Technical News Bulletin

- FlexIS Drive Replacement** – With over 800 systems installed it has become the leading control system for glass forming.
- All new drives have a safety input to safely disable the drive.
 - Any drive that is older than 6 years cannot be repaired anymore.

Introduction

The newest drives require following FlexIS Software Version (Update Package Version)

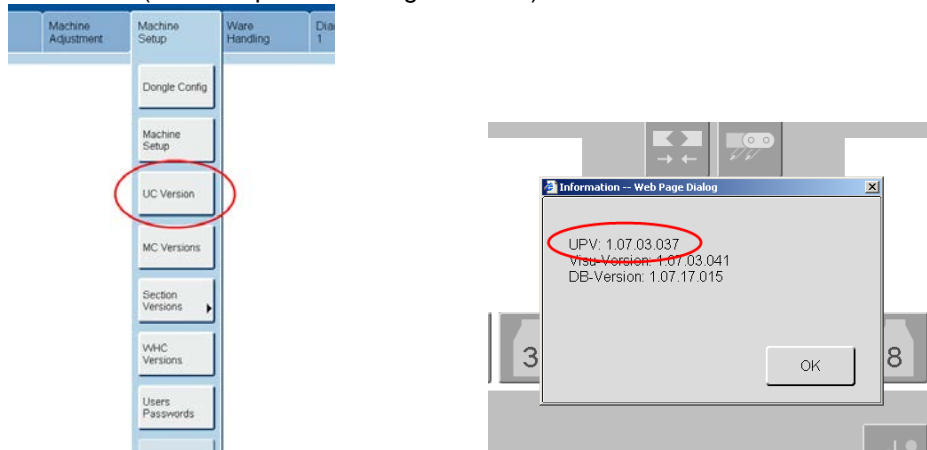
1.07.02.029 and higher (released May 11th 2012)

1.07.03.14 d higher (released January 31st 2012)

Please make sure that your FlexIS software is up to date.

Safety (STO) input

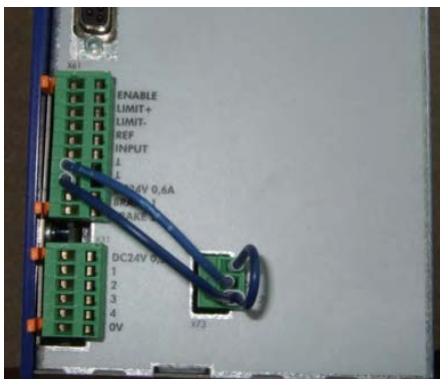
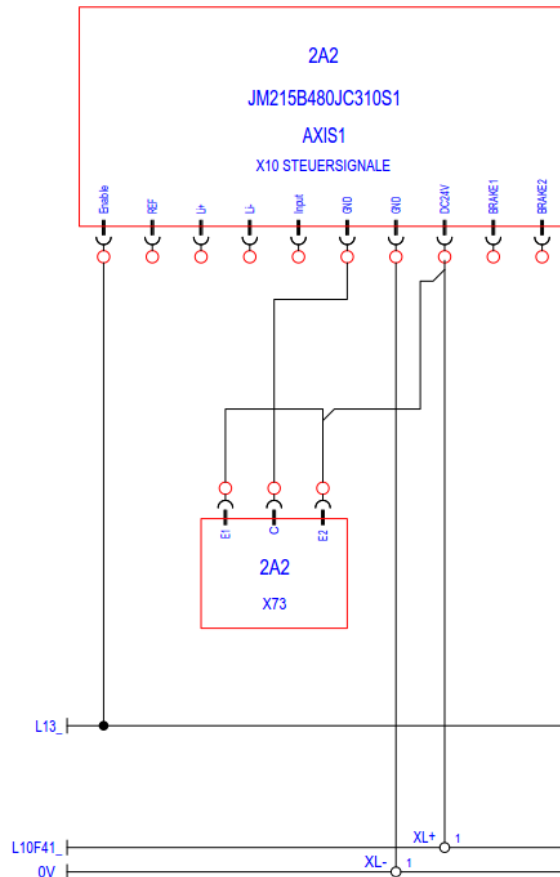
All new drives have a safety input to safely disable the drive (STO = Safe Torque Off). The old JetMove JM-215 (601-10146) did not have this safety input.

When replacing a JetMove JM-215 (601-10146) by a new model it's necessary to add some wiring. The safe enable inputs need to be powered with 24V.

Below you can see how to wire up the safe enable inputs.
 E1 and E2 need 24V which can be taken from the 24V supply of the drive.
 C needs 0V which can also be taken from the 0V supply of the drive.

601-20103

To receive the new drive (601-10847) including the wiring (601-20103) please order the drive replacement kit (601-10847-Kit)
